SUTPHEN CORPORATION SALES TECHNICAL BULLETIN

EXTERIOR MOUNTED CAB FENDER TRIM

STB-0029 – EXTERIOR MOUNTED CAB FENDER TRIM

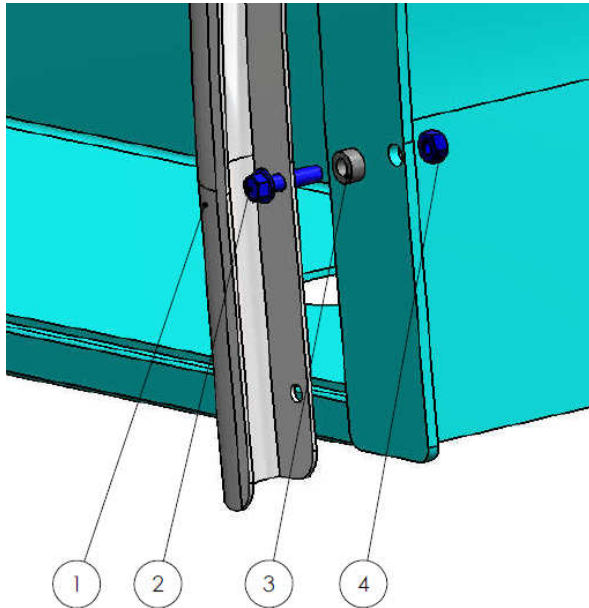
We continue to improve areas that may cause corrosion and we have redesigned the cab fender trim to eliminate the rubber gasket. After HS-5589 all Sutphen cabs will have the new style fender trim with exception to a few trucks in production. The new fender trim design prevents water and road grime from getting trapped between fender trim and the cab fender well.
